PIERCE COUNTY TERMINAL WHARF AND PHASE 2 DREDGING AND SLIP 5 MITIGATION CONTRACT NO. 998149

MANSON/TRAYLOR RECORD DRAWINGS

RECORD DRAWINGS

THESE RECORD DRAWINGS HAVE BEEN PREPARED BY ENGINEERING CONSULTANTS BASED UPON MARKUPS AND INFORMATION FURNISHED BY MANSON/TRAYLOR JV. WHILE THIS INFORMATION IS BELIEVED TO BE RELIABLE, THE CONSULTANTS CANNOT ASSURE ITS ACCURACY, AND THUS IS NOT RESPONSIBLE FOR THE ACCURACY OF THESE RECORD DRAWINGS OR FOR ANY ERRORS OR OMISSIONS WHICH MAY HAVE BEEN INCORPORATED INTO IT AS A RESULT. THOSE RELYING ON THESE RECORD DRAWINGS ARE ADVISED TO OBTAIN INDEPENDENT VERIFICATION ON THEIR ACCURACY BEFORE APPLYING IT FOR ANY PURPOSE. INFORMATION THAT IS CLOUDED REPRESENTS CHANGES MADE TO THE DESIGN DRAWINGS.

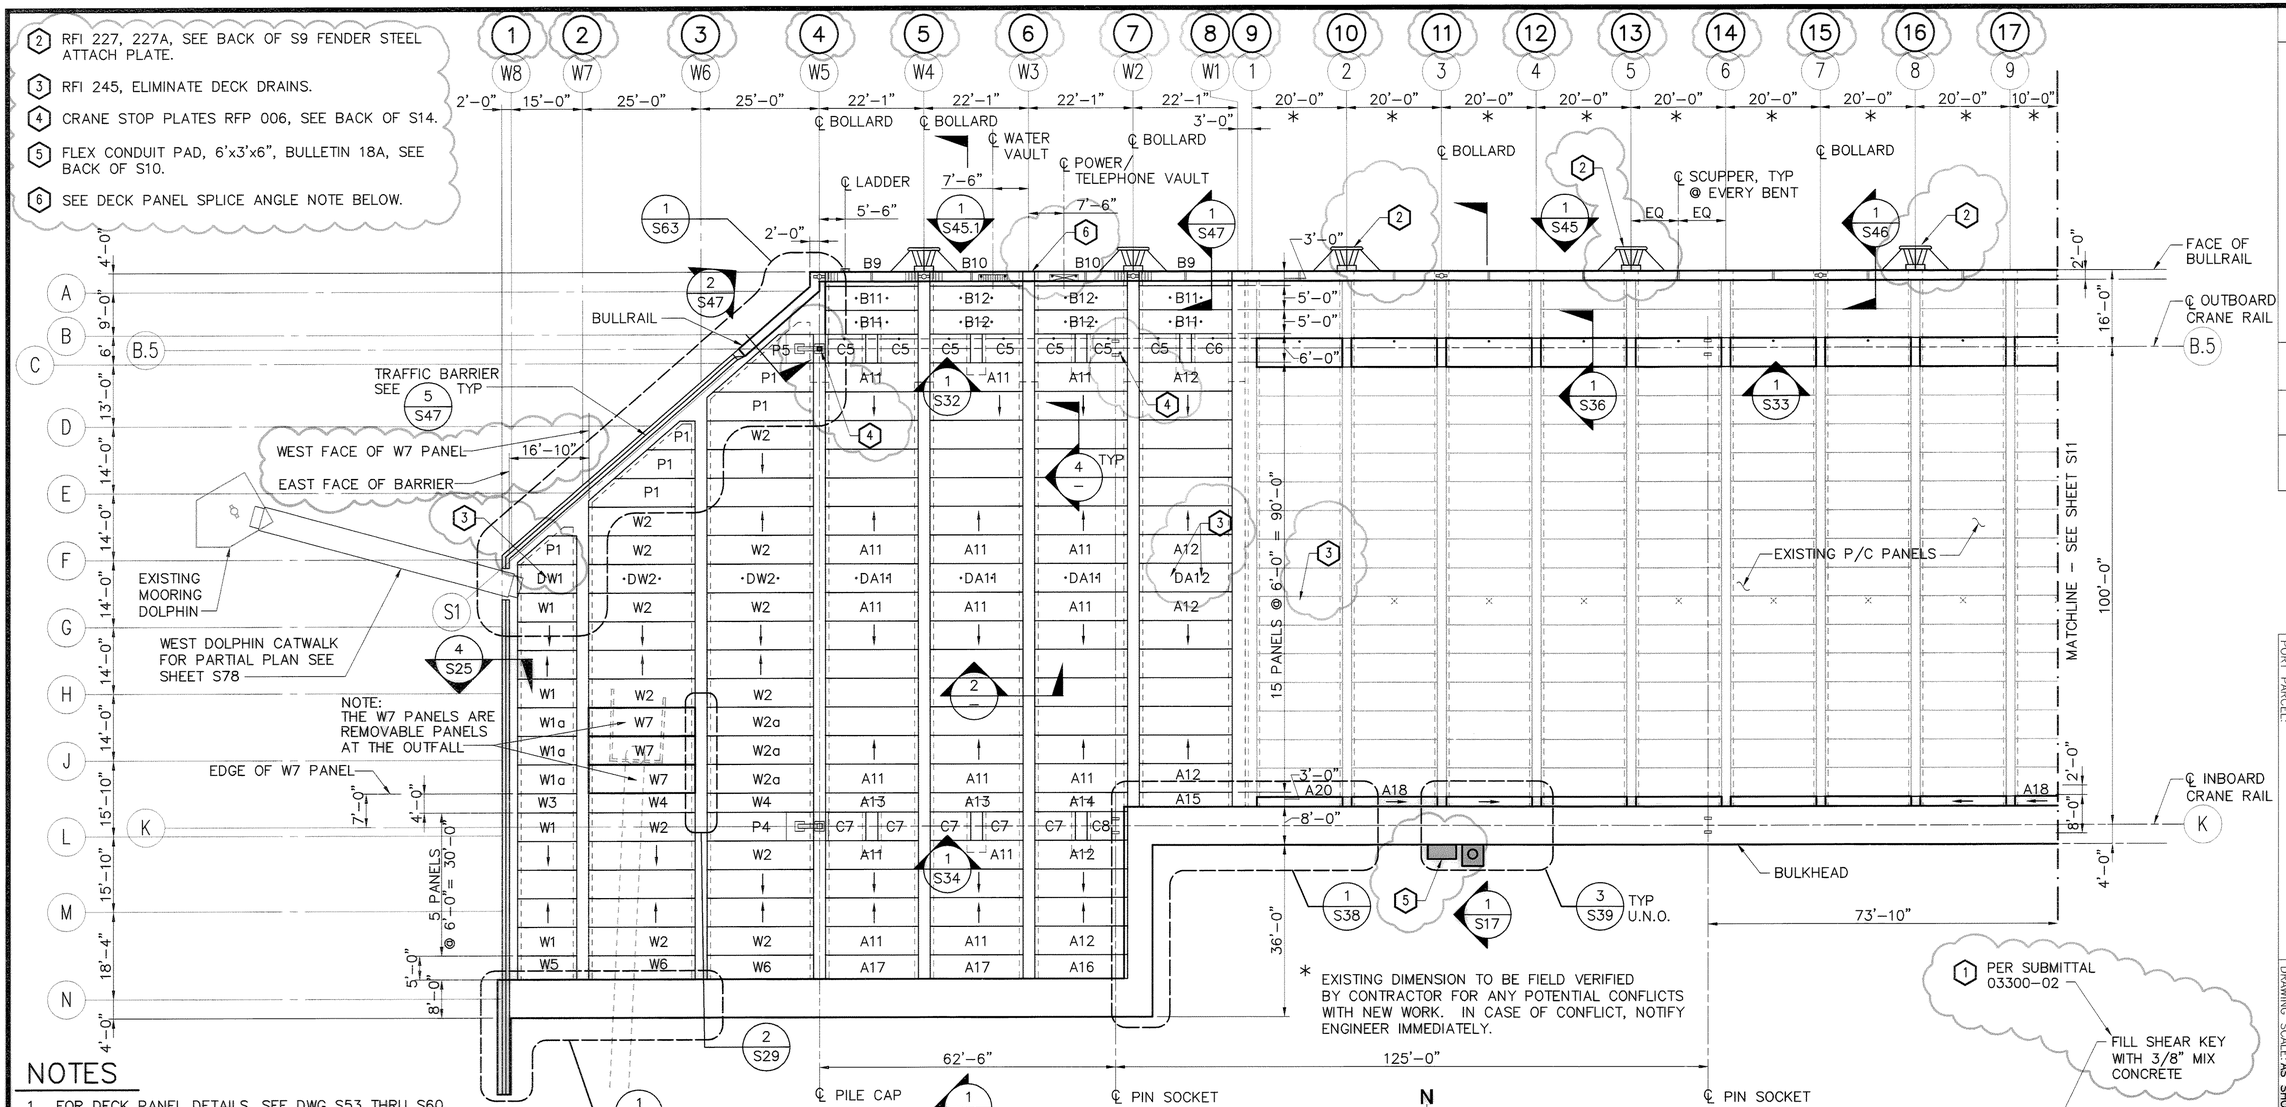
(2) RFI 227, 227A, SEE BACK OF S9 FENDER STEEL ATTACH PLATE.

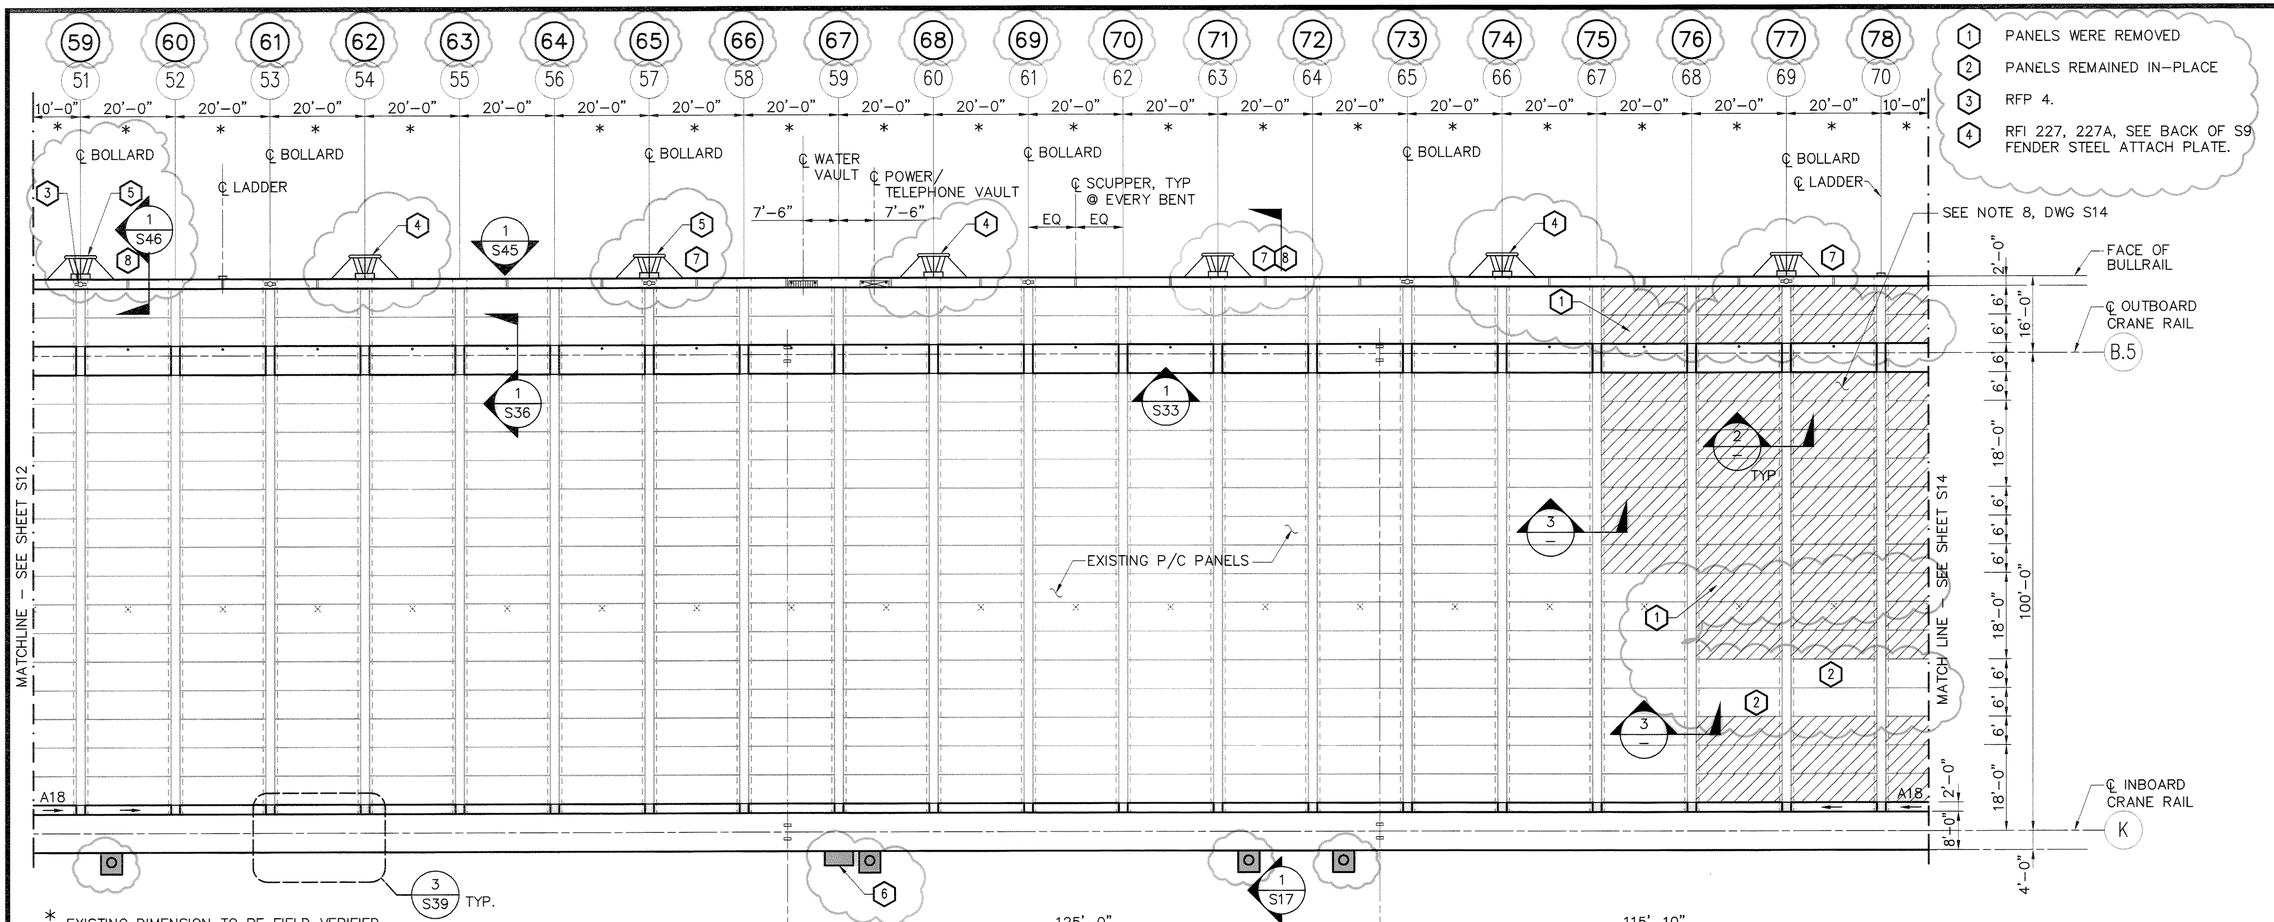
1. PANELS WERE REMOVED
2. PANELS REMAINED IN–PLACE
3. RFP 4.
4. RFI 227, 227A, SEE BACK OF S9 FENDER STEEL ATTACH PLATE.
